August 21, 1984
84056.025

Subject: Cable Tray Support Review Questions
Comanche Peak Steam Electric Station
Independent Assessment Program - Phase 4
Job No. 84056

1. Detail SP-6; Support Numbers 360 and 3011

DRAWING 2A

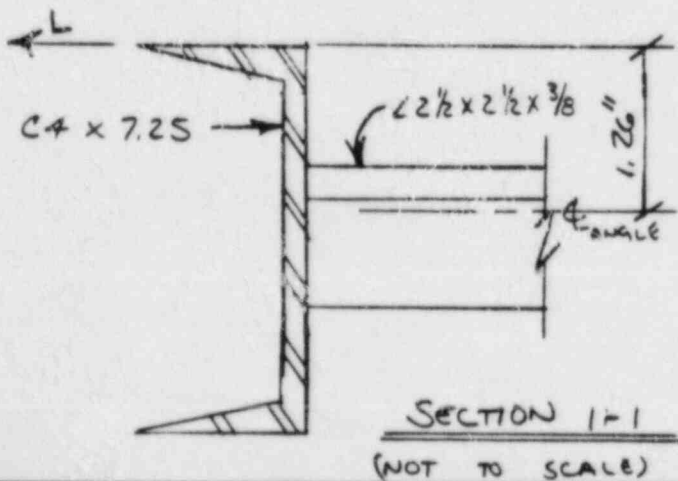
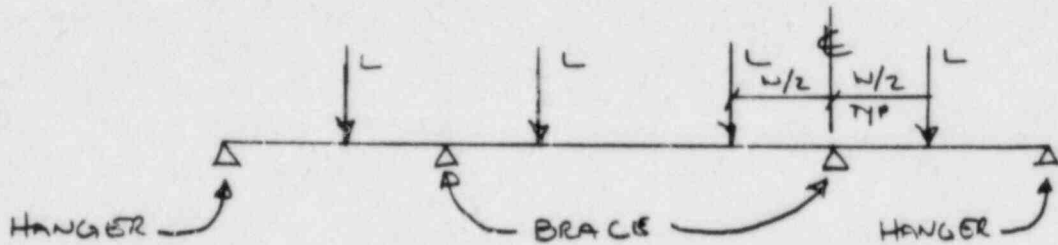
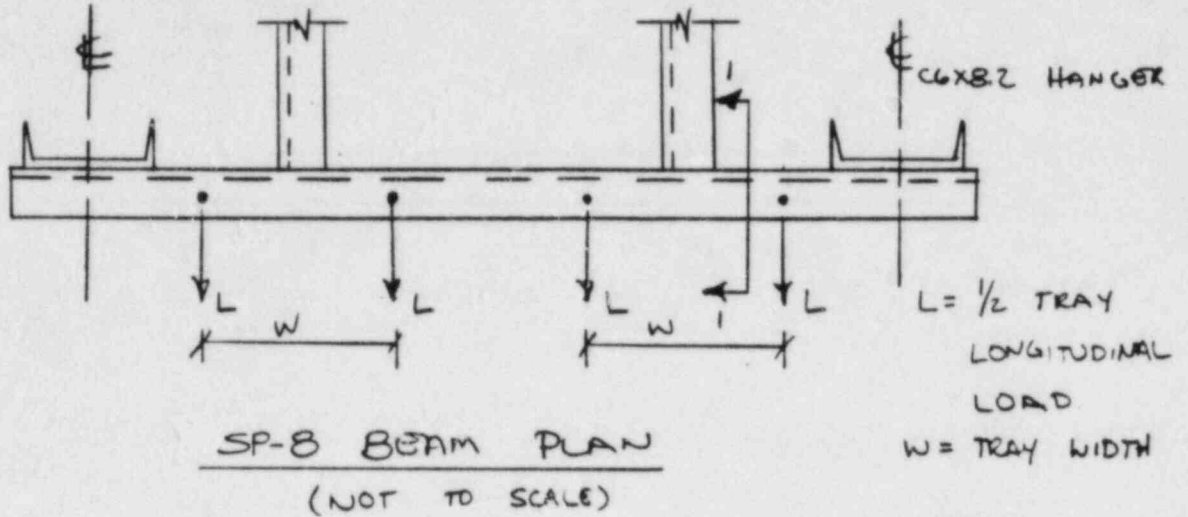
The design calculations (reference 1) assumed the support to be braced against lateral sidesway by a K-brace configuration. Therefore, it was not necessary to consider the effects of moments due to the lateral motion. The lateral brace was removed by the checker's comments, but no reanalysis to consider the effects of frame sidesway due to transverse loadings was performed.

The frame was analyzed for the effects of vertical loads using moment distribution assuming that the beam-concrete connections were pinned joints. The moment distribution was incorrectly performed since the moments from balancing of the pinned end were not carried-over to the internal joint.

The longitudinal loads were considered to be carried through the beam members to a brace which was attached to the concrete wall. The purpose of the brace was to eliminate weak-axis bending in the beam member. It is Cygna's opinion that weak axis bending as well as torsion of the beam will occur due to the imposition of the longitudinal loads. The attached drawing of the beam and brace as well as an analytical representation of the beam shows the actual eccentricities of the loads.

The stress check for the hangers was based on checking the axial stresses against an allowable of 22 ksi, or 60% of the yield stress. The hanger member has a slenderness ratio (kl/r) of 227 which is an apparent violation of AISC Code section 1.8.4. The brace members are welded all-around to the backs of the beams which provides a moment connection. The braces are also welded to the base angle on one leg only which provides an eccentric load transfer to the base angle. Such moments and eccentric loads were not considered in the design of the brace.

The hanger connections for Detail SP-8 were based on those for Detail SP-3. It is not clear how the hanger connections for Detail SP-3 qualified the connections of an SP-8 since the loads for Detail SP-8 were not clearly determined to make a comparison possible. The connection employing a single Richmond Insert for Detail SP-3 will result in an interaction ratio greater than one when the allowable values from Gibbs & Hill specification 2323-SS-30 are used to check the bolt loads. The design of the hanger connections using Hilti expansion anchors for Detail SP-3 also assumed that a compression force is mobilized in the concrete, thus indicating a moment-resistant connection. Such an assumption is

contrary to the original assumption that the hanger-concrete connections are pinned. Allowable eccentricities were also calculated for the hanger connection, but the eccentricity formula does not consider the increase in tensile loads due to prying action.

The brace connection for Detail SP-8 was checked for the design loads of the support. Richmond Inserts used to anchor the brace to concrete were checked for a design load which did not include the accelerated mass of the trays and the support, therefore the load applied to the inserts was too small. Also, the effects of the eccentric loadings from the brace member were not checked. The connection of the brace which employs Hilti expansion anchors did not consider the effect of such eccentric loadings. An allowable eccentricity of the brace location on the base angle is specified, but the calculation of the eccentricity was not shown.

Support 455 was reviewed by Cygna and checked in the field during the walkdowns. The installed support does not contain braces which restrain lateral movement. The braces for the longitudinal loads were moved such that they are located at the centerlines of the hanger members. At this location they provide no load transfer of the longitudinal loads to the concrete through the beam members. Thus, weak-axis bending and torsion must be resisted by the beam members alone.

- (a) The capability of generic SP-8 supports to resist the effects due to lateral loads;
- (b) The capability of the beam members to resist weak-axis bending and torsional moments;
- (c) The use of a member which has a slenderness ratio in opposed violation of AISC Code section 1.8.4;
- (d) The capability of the brace members to resist eccentric loads;
- (e) The suitability of the Detail SP-3 hanger connections for use on SP-8 supports;
- (f) The capability of the anchor bolts used in the brace design to resist the design loads;
- (g) The capability of Hilti expansion anchors to resist design loads which are eccentrically applied to the base connection;
- (h) The acceptability of the allowed eccentricity for the brace connection; and
- (i) The capability of support 455 to resist the applied loads including the effects noted above.

DRAWING 3A

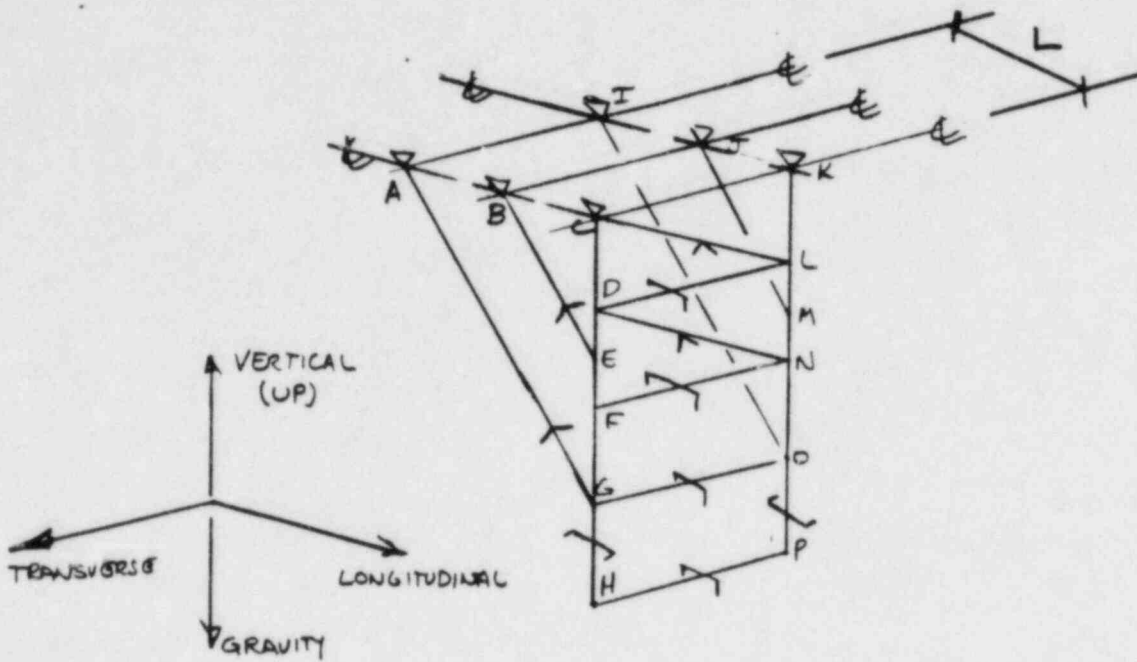
A representation of a typical Regular Case L-A₄ support is shown on the attached sheet 3A. The analytical model of the support consisted of members CDEFGH, BE and AG. Boundary conditions were assumed as pinned ends for joints A, B, C, E and G. A vertical load was applied in the gravitational direction at node H. A longitudinal load was also applied at node H. Transverse loads were not considered in the analysis.

It is Cygna's opinion that the analytical model as described above is inadequate to correctly predict the behavior of the support under the applied loadings. By considering only a planar frame rather than a space frame, several important loading effects were neglected. The primary effect is the bending moment induced into the beam member HP by vertical loads. These could not be predicted because beam member BE was not modeled and the vertical and longitudinal loads were applied at node B. Reference 3 shows the beam-hanger joints as moment resisting connections. Therefore, vertical and longitudinal loadings within the span of the beam will induce flexural and torsional moments into the hanger members CDEFGH and KLMNOP.

As noted above, the effects from transverse loadings were not considered in the analysis. Thus, axial loads, as well as moments resulting from frame sidesway were neglected in the beam and hanger members.

Brace members CL and DN were not designed because the support was modeled as a planar structure. Brace members AG, BE, IO and JM were not designed for the eccentric application of loads. Such eccentric loadings will induce moments into the angle sections that must be considered in the design.

- (a) The capability of Regular Case L-A₄ cable tray supports to resist the design loads. Please discuss the effects due to transverse loads as well as those local effects due to vertical, transverse and longitudinal loadings;
- (b) The capability of the bracing members to resist eccentrically applied loadings;
- (c) The suitability of using a moment arm to individual bolts rather than the centerline of the base attachment to which they connected; and
- (d) The capability of the anchor bolts to resist the design loads.

DRAWING 3B

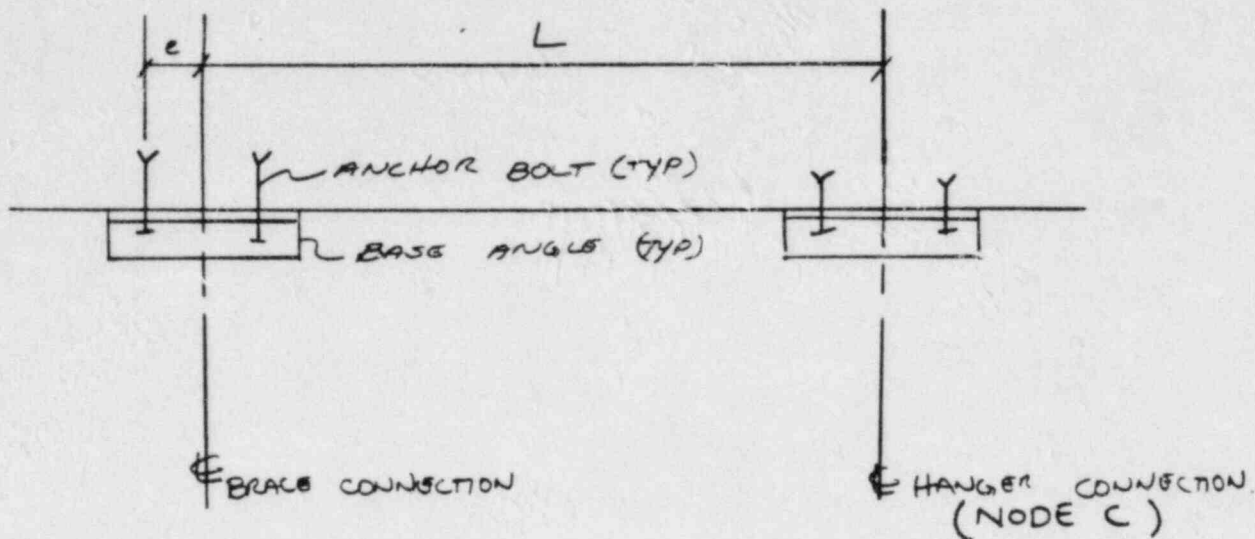
The original design calculations (reference 2) were not consistent in the application of loads for checking anchor bolts. The anchor bolts were checked for the shear and tension forces due to longitudinal loads only. The effects from both vertical and transverse loads were ignored. In checking the anchor bolts, moments of the applied longitudinal load were taken about node C and a resisting bolt tension was calculated at node A. The moment arm to point A was calculated as $L + e$ rather than L as shown in the attached sketch 3B. The use of the larger moment arm results in a bolt tension 4% smaller than actual.

Based on longitudinal loads only, all anchor bolts exceeded 1.0 in the interaction ratio. To qualify the bolts, and therefore the support, the values of allowable horizontal acceleration, longitudinal tray span or the tray width were calculated. Below any of these levels, the support was considered adequate to resist the applied loads.

DRAWING 4A

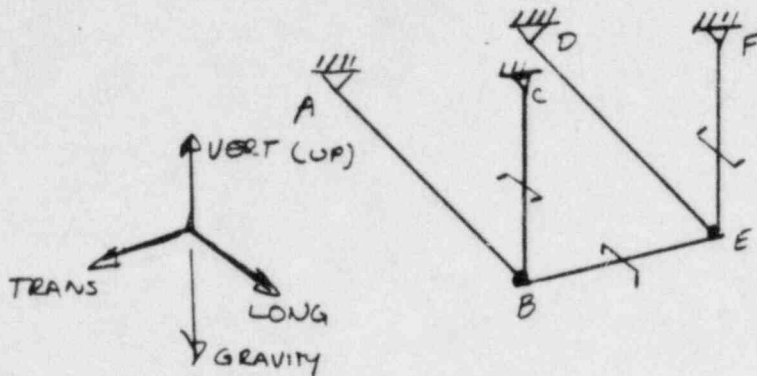
A representation of a typical Regular Case L-A₁ support is shown on the attached sheet. The analytical model of the support consisted of only members AB and BC. Boundary conditions were assumed as pinned ends for joints A, B and C. A vertical load was applied in the gravitational direction at node B. A longitudinal load was also applied at node B. Transverse loads were not considered in the analysis.

It is Cygna's opinion that the analytical model, as described above, is inadequate to correctly predict the behavior of the support under the applied loadings. By considering only a planar frame rather than a space frame, several important loading effects were neglected. In particular, the effects of the vertical and longitudinal bending moments induced into the beam member BE were not considered. These moments could not be predicted because beam member BE was not modeled and the vertical and longitudinal loads were applied at node B. Reference 3 shows the beam-hanger joints as moment resisting connections. Therefore, vertical and longitudinal loadings within the span of the beam BE will induce flexural and torsional moments into the hanger members BC and EF.

As noted above, the effects from transverse loadings were not considered in the analysis. Thus, axial loads as well as moments resulting from sideway were neglected in the beam and hanger members.

Eccentric loadings of the brace member were not considered in the analysis and design of the frame. Such eccentric loadings will induce moments into the angle section that should be considered in the design.

The original design calculations (reference 2) were not clear in their stress and load checks for support members and anchor bolts. Sheet 3 of reference 2 notes a check for weak axis flexural stresses of the hanger member. It is not clear to Cygna how such moments were calculated since the frame analysis does not consider loadings, in this case transverse, which will induce such moments. This check also noted stresses which exceed allowable levels. A check on beam flexural stresses due to longitudinal loads shows a 5% overstress without consideration of the effects due to vertical and transverse loads. The anchor bolts were checked for longitudinal loads only.

- (a) The capability of Regular Case L-A₁ cable tray supports to resist the design loads. Please discuss the effects due to transverse loads as well as those local effects due to vertical, transverse and longitudinal loadings;
- (b) The capability of the bracing members to resist eccentrically applied loads; and
- (c) The capability of the anchor bolts to resist the design loads.
